CITY OF WEST LAKE HILLS, TEXAS  
NOTICE OF ZONING & PLANNING COMMISSION (ZAPCO) REGULAR MEETING  
Wednesday, May 15, 2024 at 6:30 PM

## MINUTES OF A ZONING & PLANNING COMMISSION (ZAPCO)

406 REDBUD TRAIL  
#2023-14

VARIANCE  
PRESENTATION

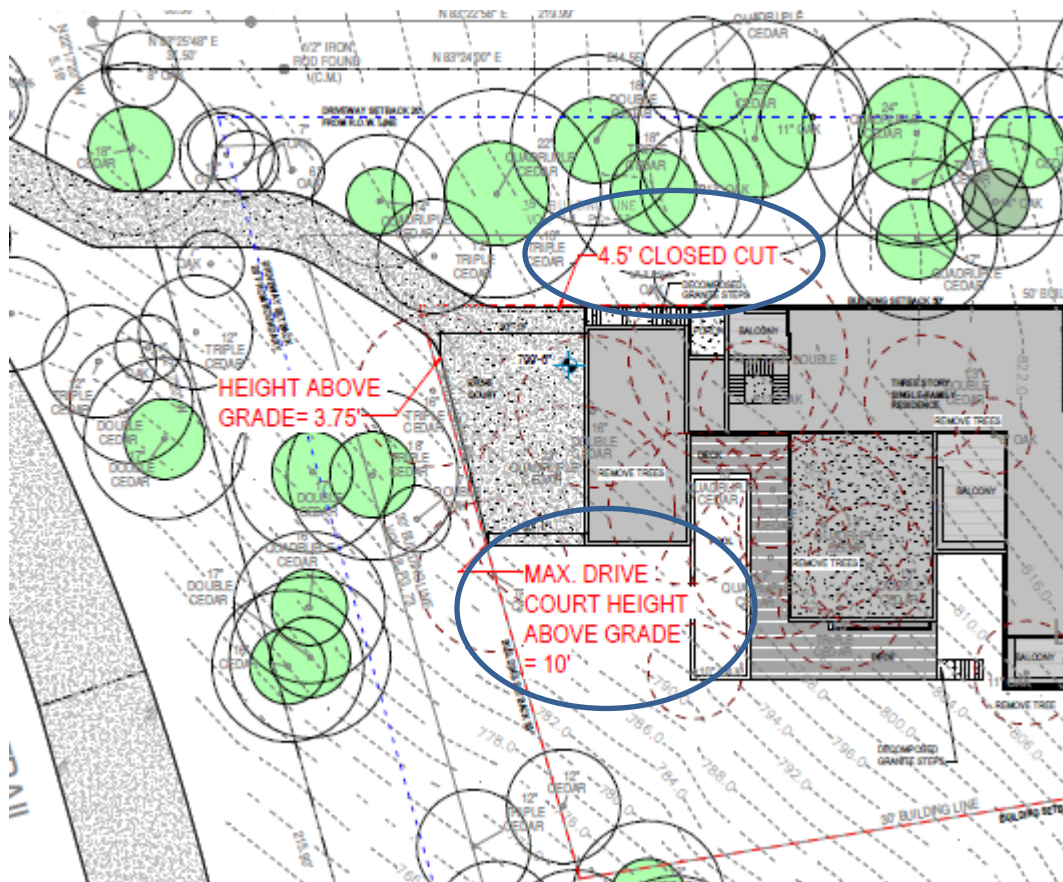
As shown on the existing survey, the property has a considerable slope from northeast to the southwest. The "flattest" part of the property 0-25% slopes, is to the north in the 50-foot setback, that contains a significant stand of protected trees.

The remainder of the lot has slopes between 15% - 35%. The applicant has sited the driveway to meet access requirements and sited the maneuvering area (drive court) to the front of the house, which limits visibility to surrounding neighbors and will be screened by existing trees. In this location, with the slope, the drive court will be cut into the grade 4.5 feet on the north side and filled 10-foot above grade on the south side.

Staff recommend **approval** of the variance. Given the slope on the property, to make a level driveway and maneuvering area for access, a cut or fill greater than the allowances in the table would be required. This location would have a minimal impact on surrounding neighbors.

PROPOSED SITE PLAN- CUT AND FILL

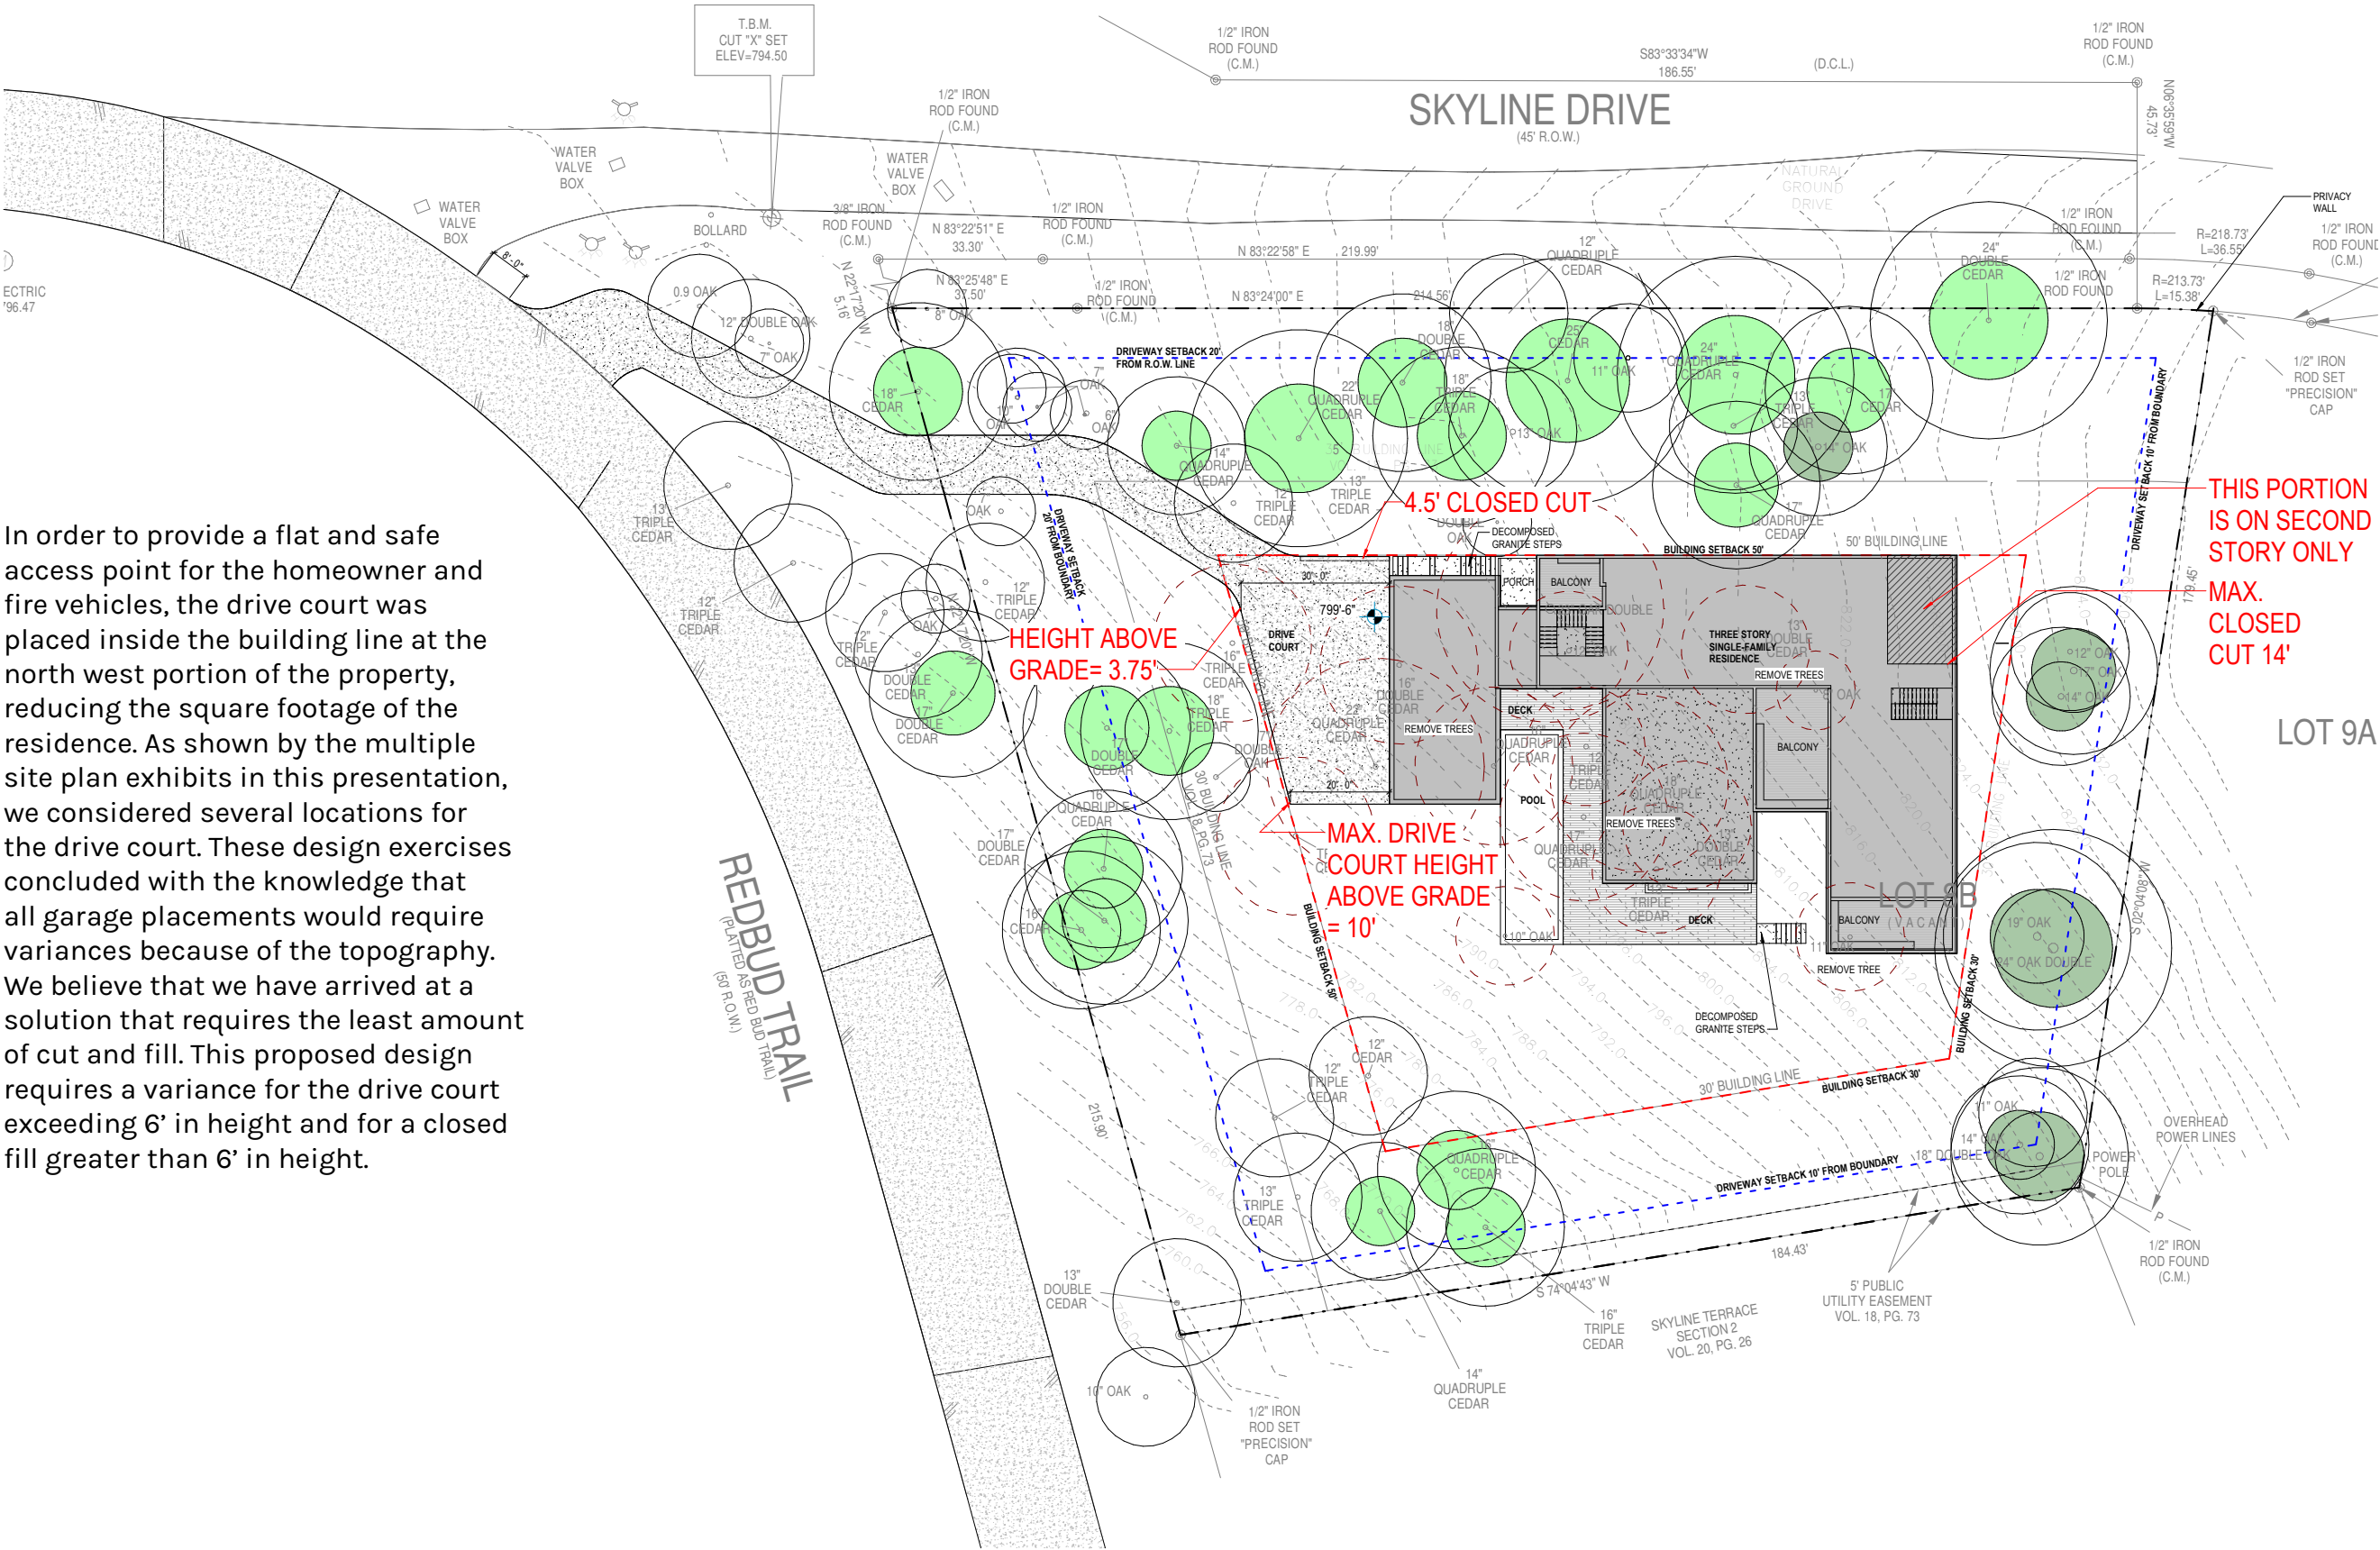
In order to provide a flat and safe access point for the homeowner and fire vehicles, the drive court was placed inside the building line at the north west portion of the property, reducing the square footage of the residence. As shown by the multiple site plan exhibits in this presentation, we considered several locations for the drive court. These design exercises concluded with the knowledge that all garage placements would require variances because of the topography. We believe that we have arrived at a solution that requires the least amount of cut and fill. This proposed design requires a variance for the drive court exceeding 6' in height and for a closed fill greater than 6' in height.

TREE MITIGATION AND LANDSCAPING PLAN

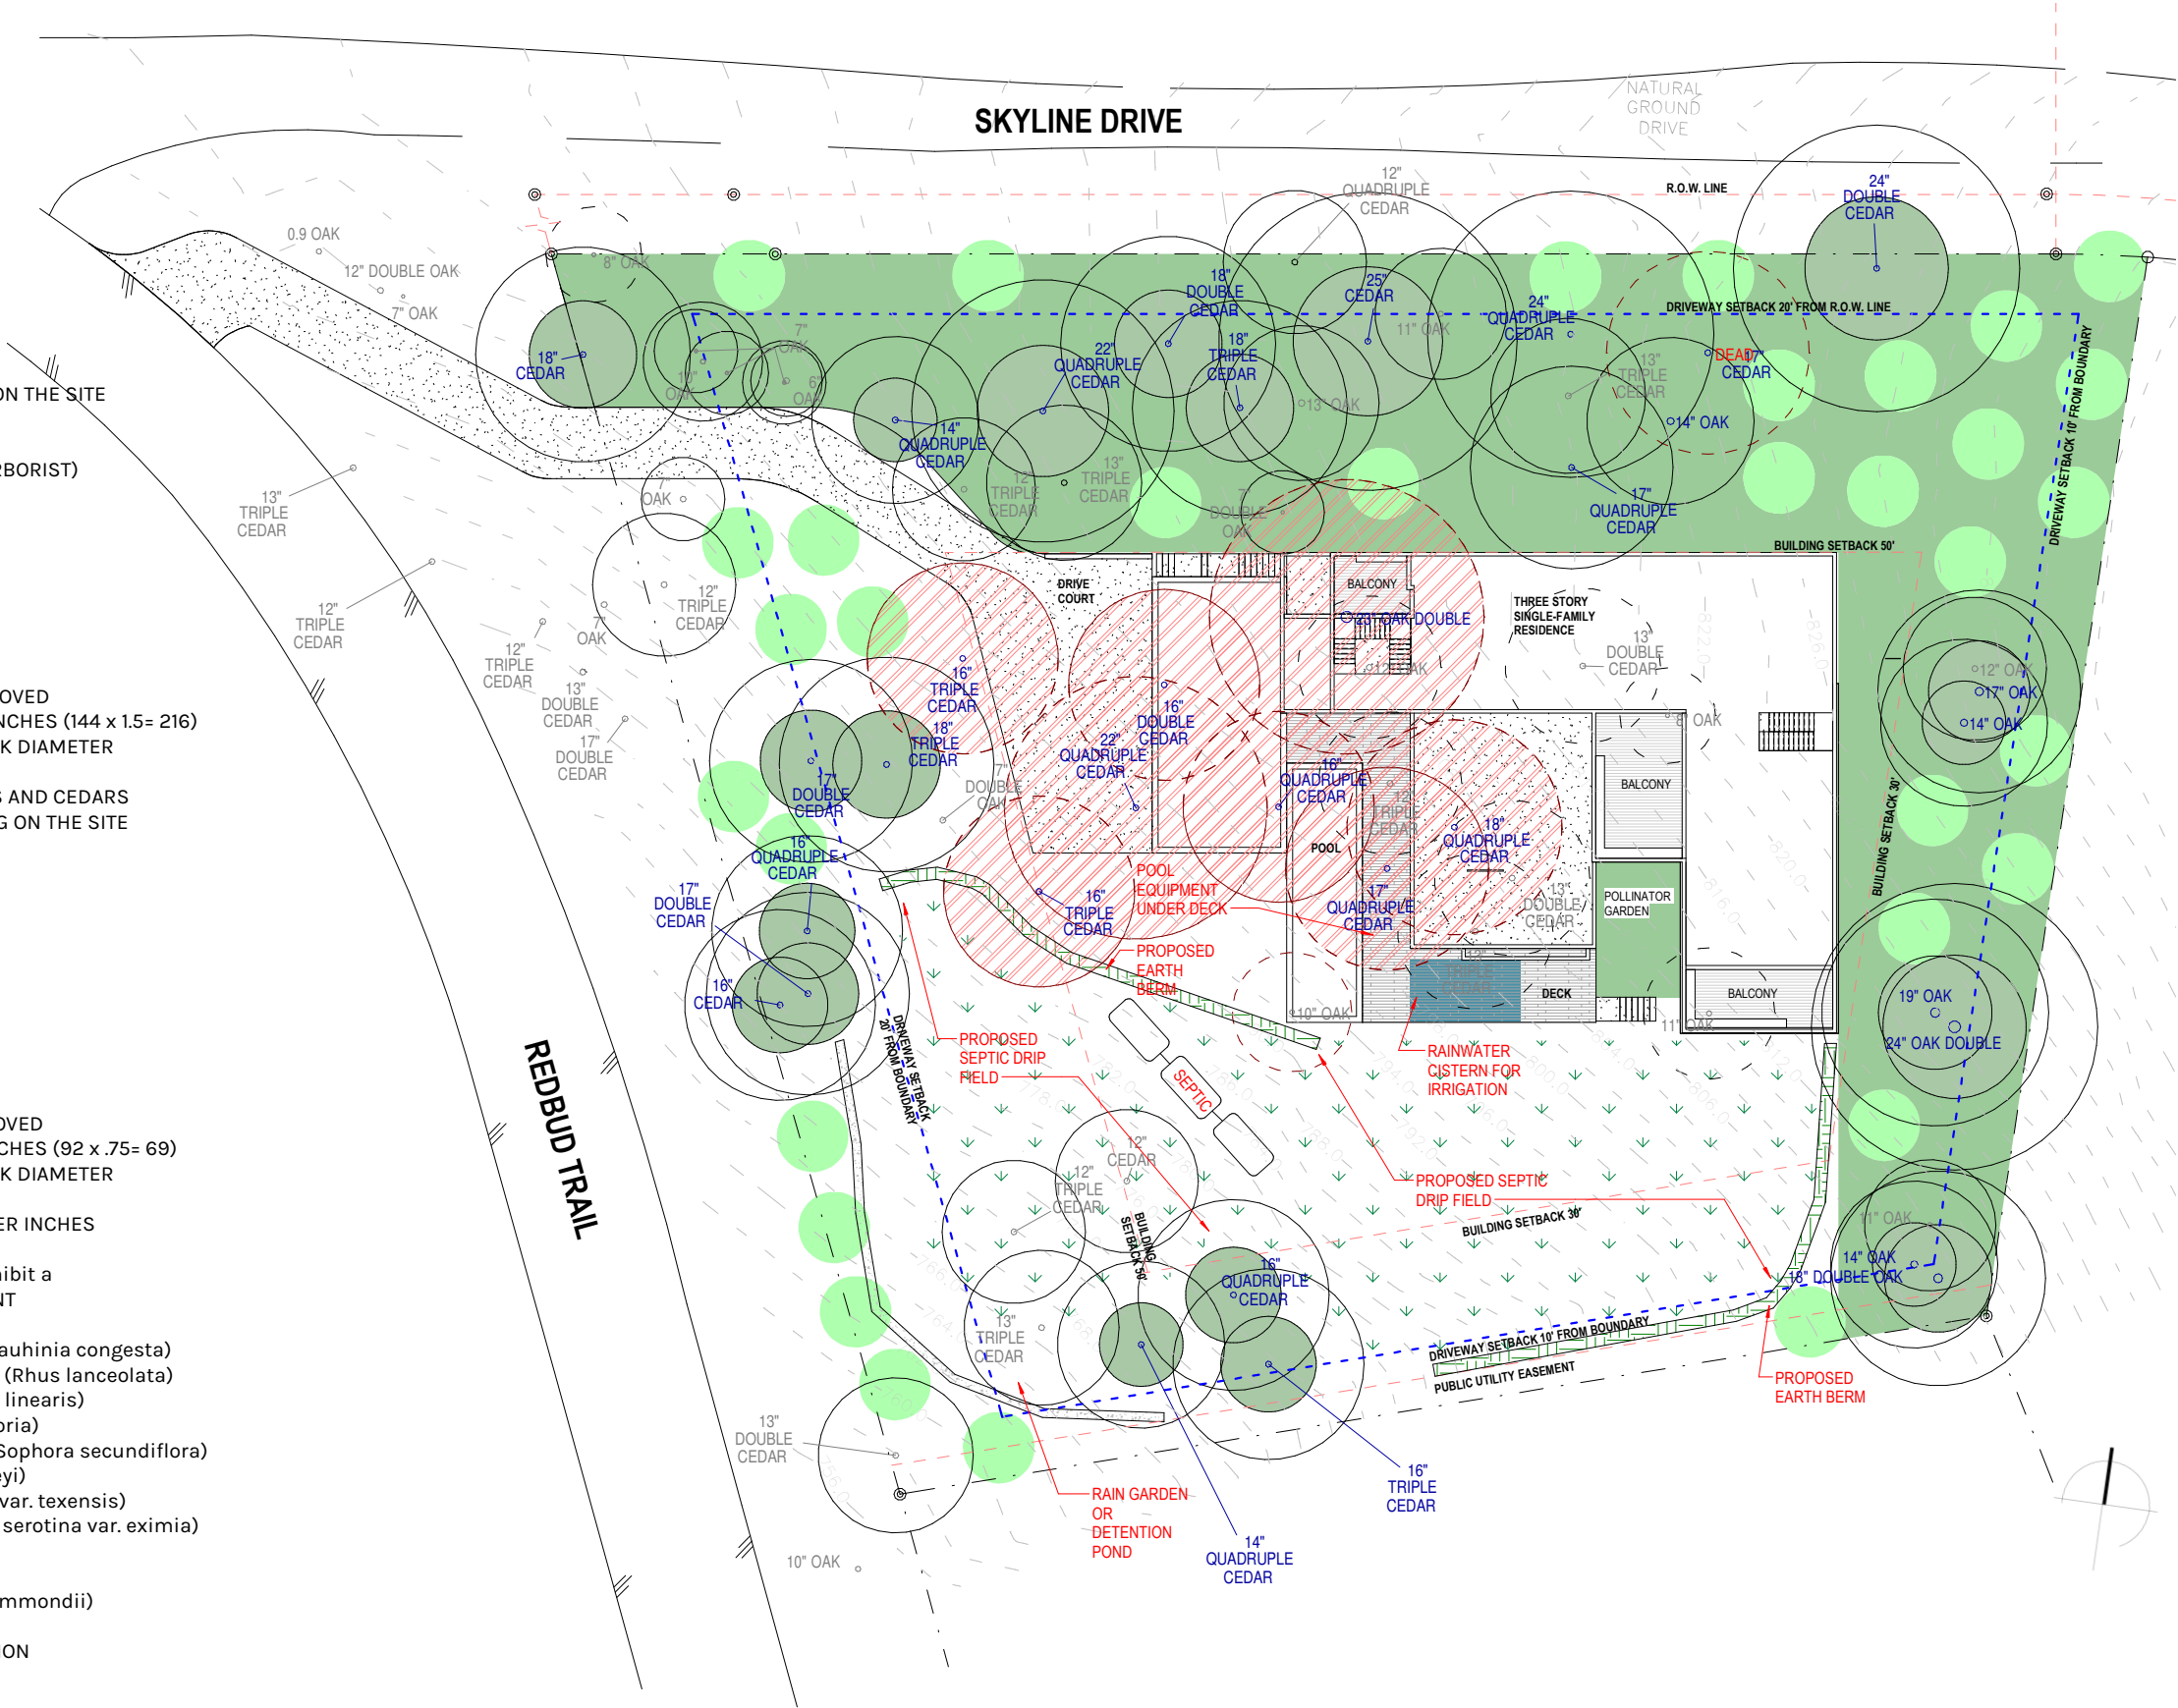
Per the arborists report, the healthiest trees with the most potential are located along the East edge of the property outside the buildable area. The current design preserves these trees and creates many spaces for new landscape and native plantings. The extreme slope of the lot has led to little diversity of flora or fauna, but carefully planned landscaping around the new residence can increase the health and diversity of the plants and animals on the property.

- # TO BE REMOVED= 7
- 12" OAK
  - 13" DOUBLE CEDAR
  - 8" OAK
  - 11" OAK
  - 13" DOUBLE CEDAR
  - 13" TRIPLE CEDAR
  - 12" TRIPLE CEDAR
  - 10" OAK

TOTAL OF 92 CALIPER INCHES TO BE REMOVED  
PROPOSED MITIGATION OF 80 CALIPER INCHES (92 x .75= 69)  
REPLACEMENT TREES MUST BE > 2" TRUNK DIAMETER

**TREES TO BE REMOVED**

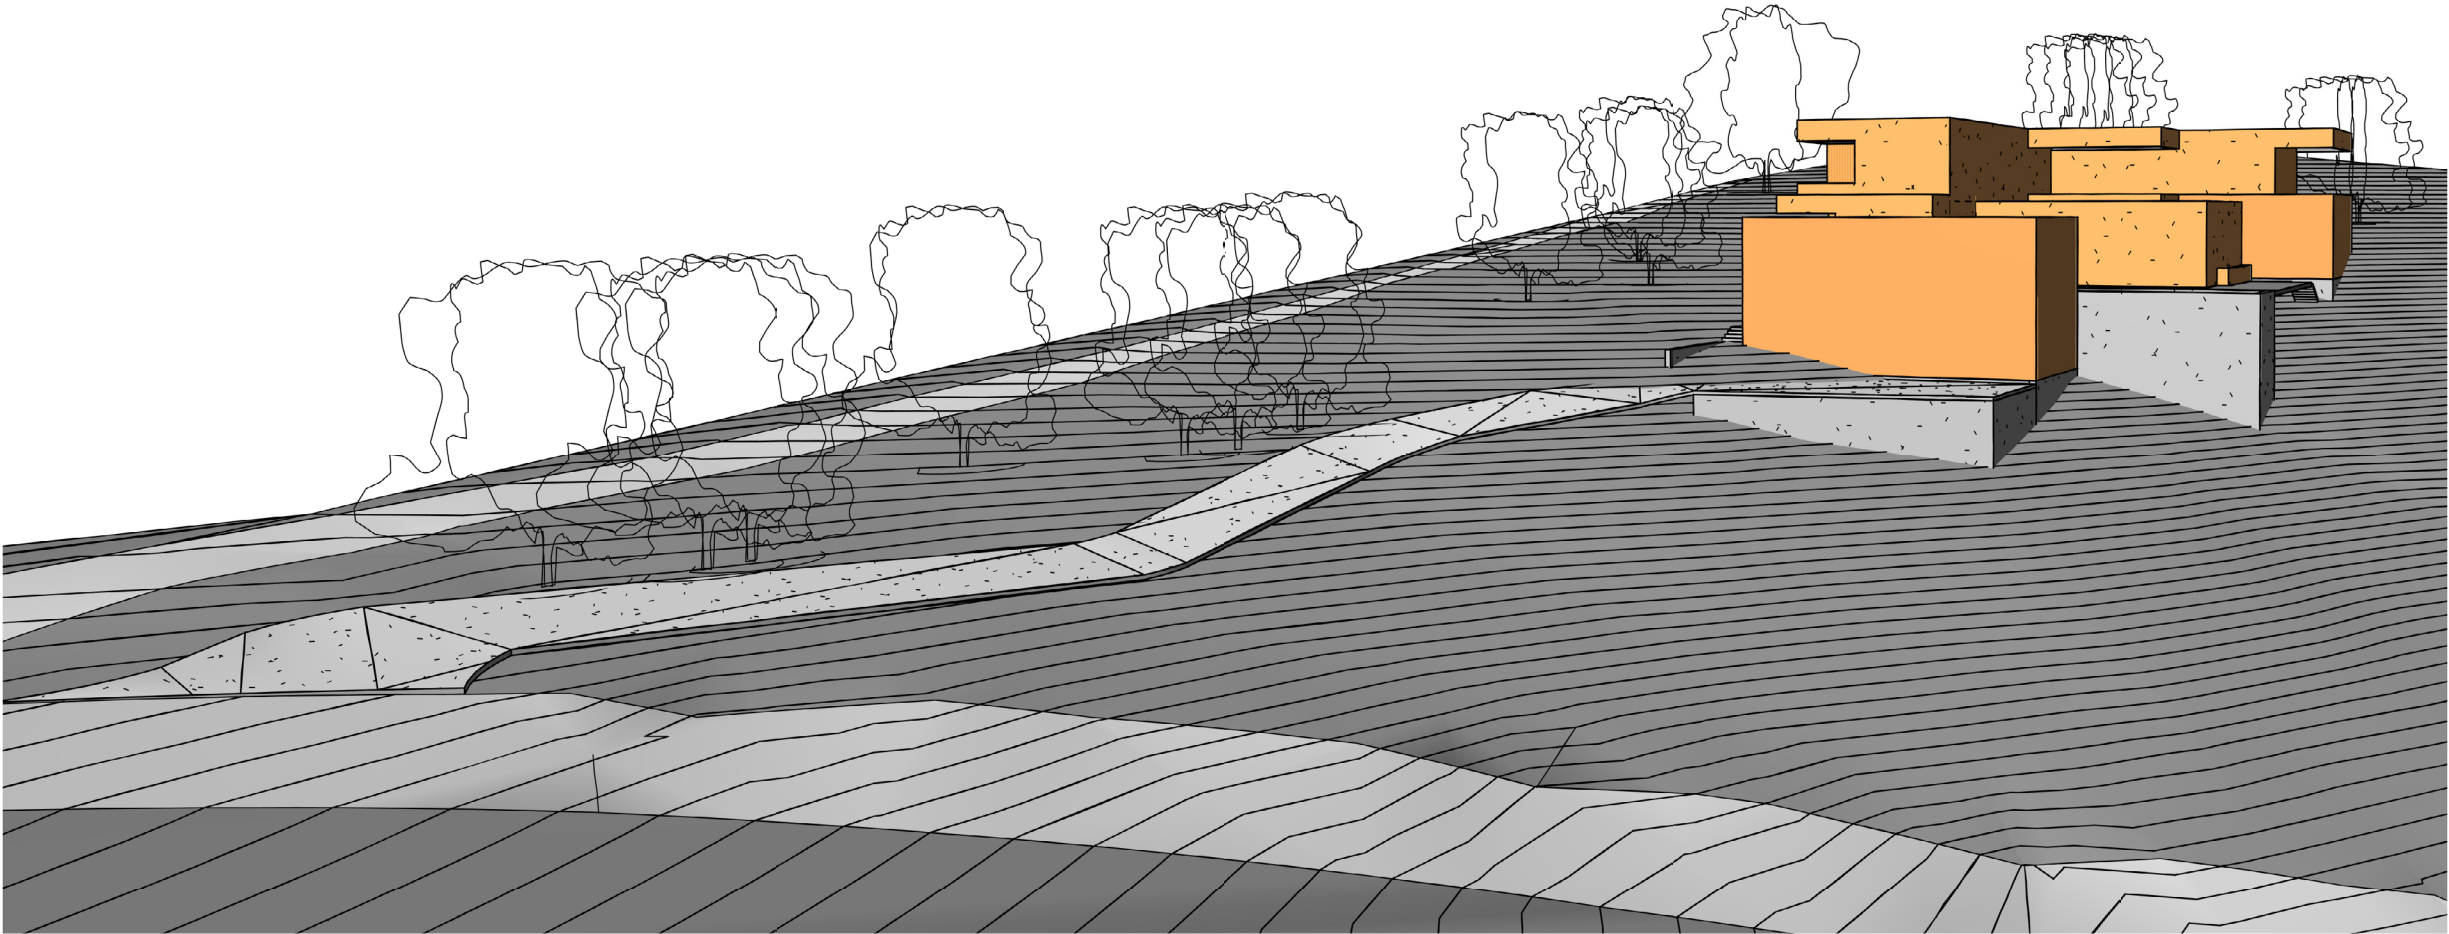
**22"QUAD CEDAR TO BE REMOVED- FAIR  
CONDITION (TREE 5572 IN ARBORIST REPORT)**

**16" QUADRUPLE CEDAR TO BE REMOVED**

**17" QUADRUPLE CEDAR TO BE REMOVED**
